DUKE POWER COMPANY

Re: RII:WCL  
50-413/83-22  
50-414/83-19

Duke Power Company  
Catawba Nuclear Station

Contrary to the above, design calculations for problems CN-1492-NB-152A, Rev. 1 and CN-1492-NB-267A, Rev. 3 did not meet the above requirements in that:

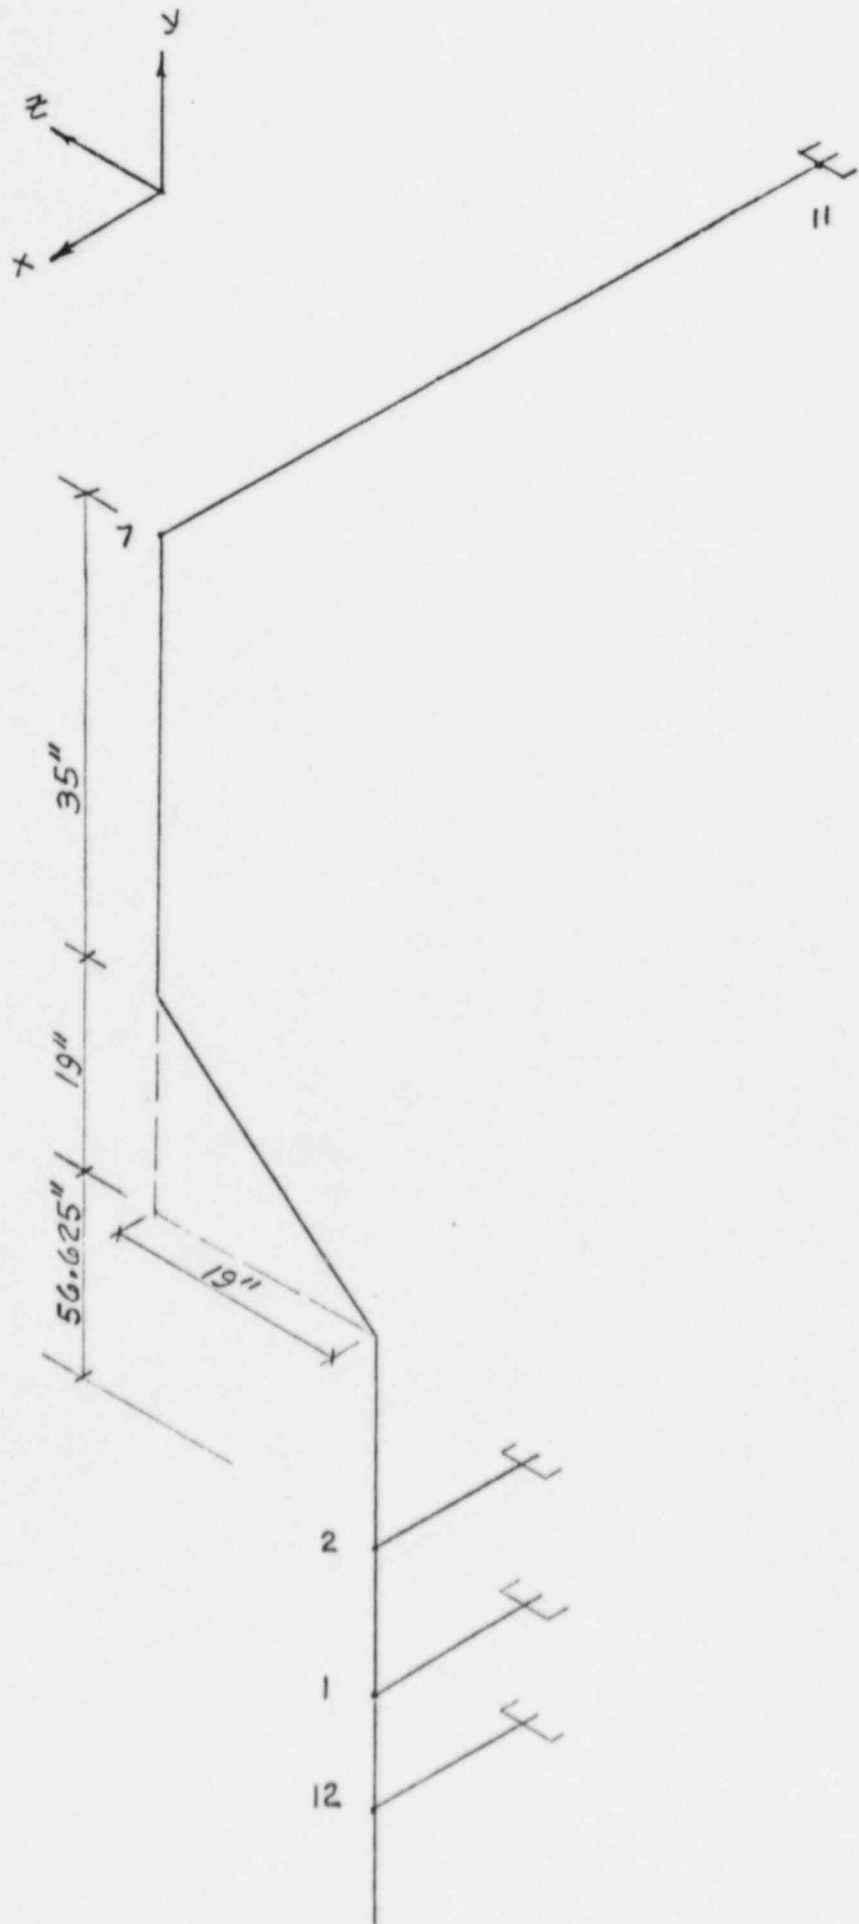
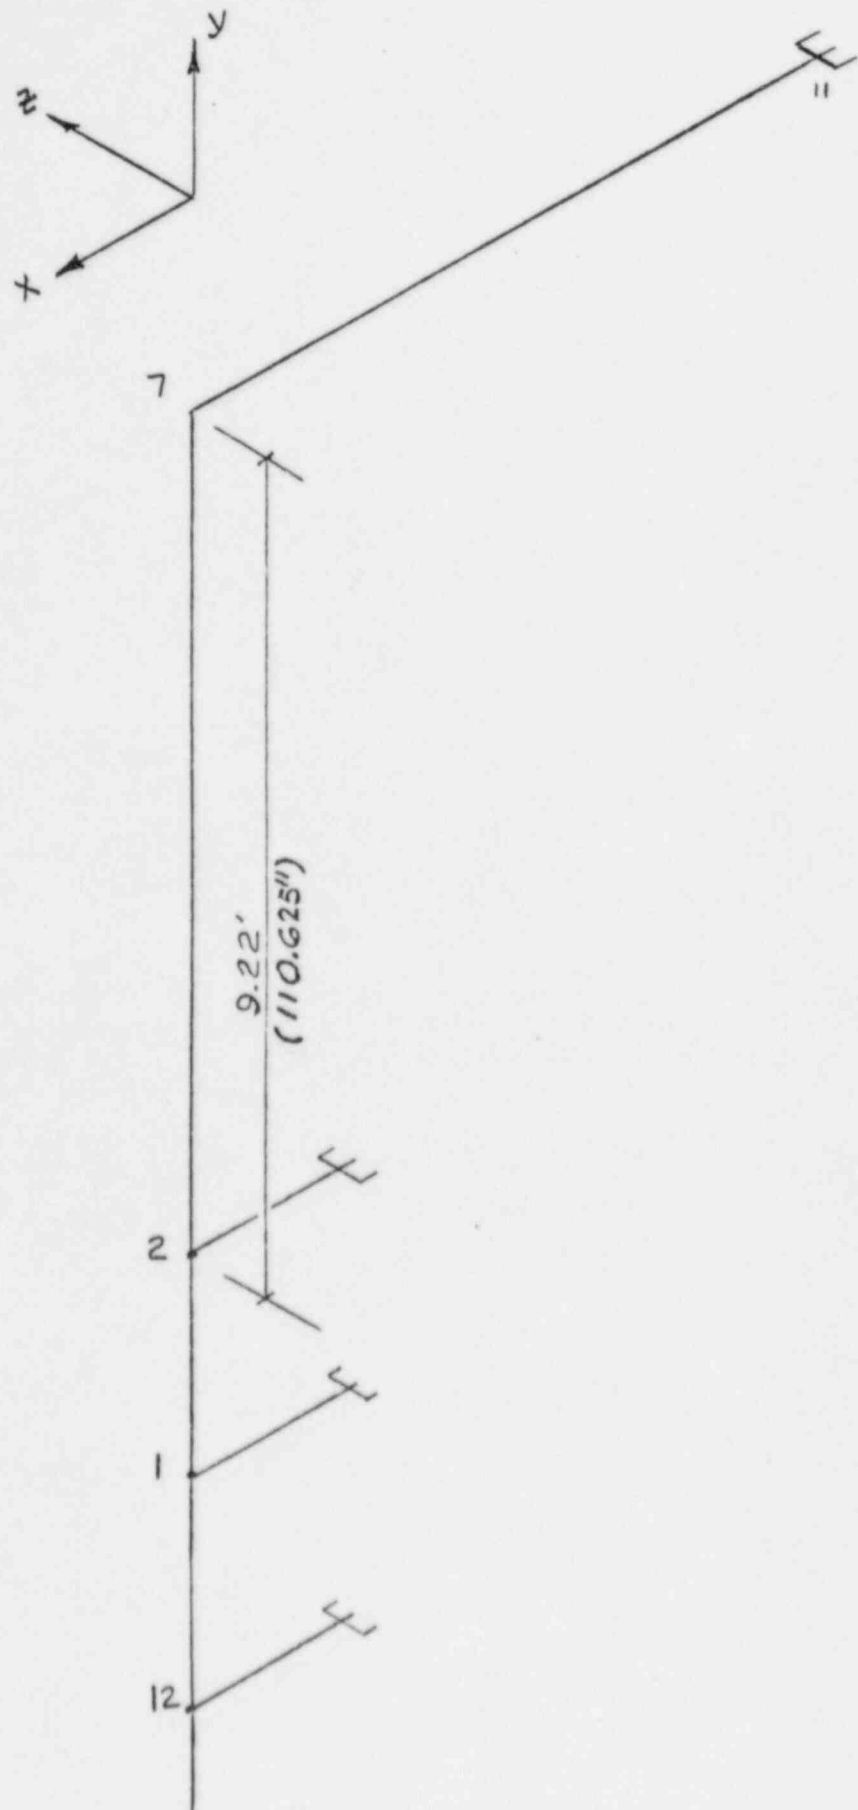
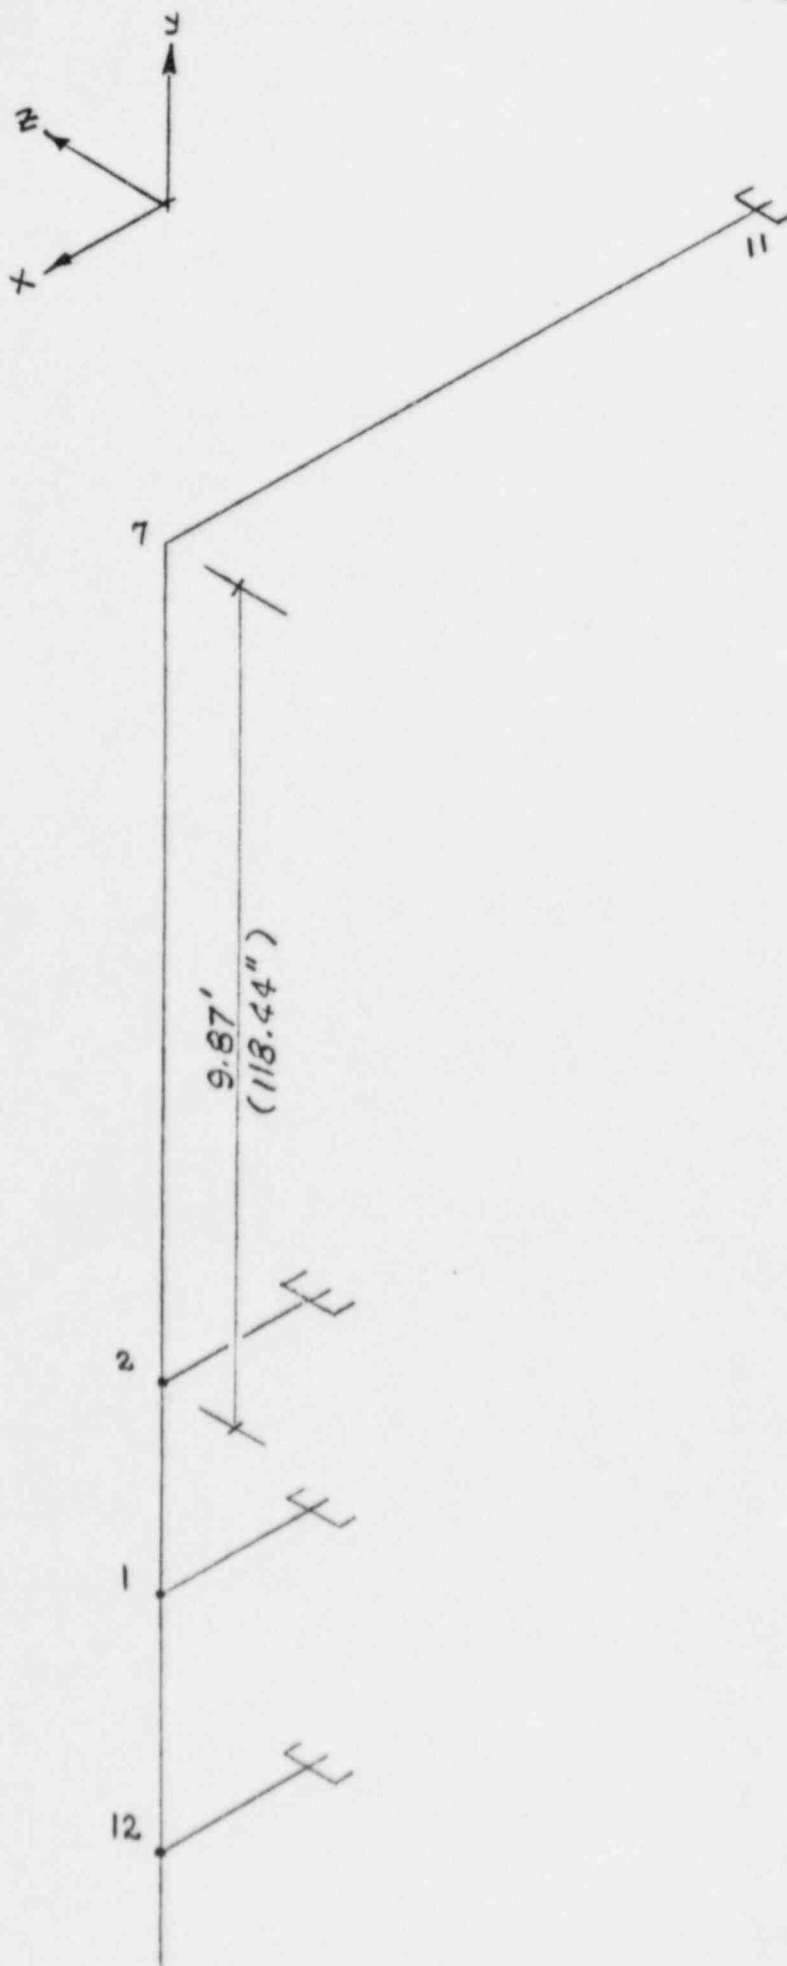
3. In problem CN-1492-NB-179A the thermal growth from the rigorous anchor on isometric CN-1492-NB-152A is absorbed into a piping run that contains a 45° offset that is perpendicular to the thermal displacements. The criteria presents idealized piping configurations and it is the task of the designer to relate the actual configurations to the cases presented in the criteria. It has been the general practice of the Catawba Alternate Analysis Subgroups to use the summation of lengths of each section to determine the equivalent bending length whenever a bending leg contains an offset of 45° or less, perpendicular to the thermal displacements. In order to verify the validity of this practice we have run a computer analysis of the segment of piping questioned using three different configurations. (See attached sketches). The thermal deflection of 0.3151 was input and the resulting force at the anchor was compared among the three cases and with the results of the force calculated by the designer in the calculation. The results are shown below:

Case 1: Computer run of the actual piping configuration including the 45° offset.	<u>Force at Anchor</u> 61.76 lbs.
Case 2: Computer run of the piping configuration with a straight run using the projected length of the offset (Method suggested by the inspector.	67.00 lbs.

Case 3: Computer run of the piping configuration with a straight run using the summation of each piping segment lengths. (Method used in the calculation) 57.24 lb.

Case 4: The use of the summation of each piping segment length for an equivalent length to be used in the Alternate Analysis Criteria. (Taken directly from calculation) 143 lb.

As can be seen from the results, Case 3 gives results closer to the results of Case 1 than does Case 2; and Case 4, which is the past and current practice, gives an extremely conservative approximation of the force as compared to either of the computer analyses.
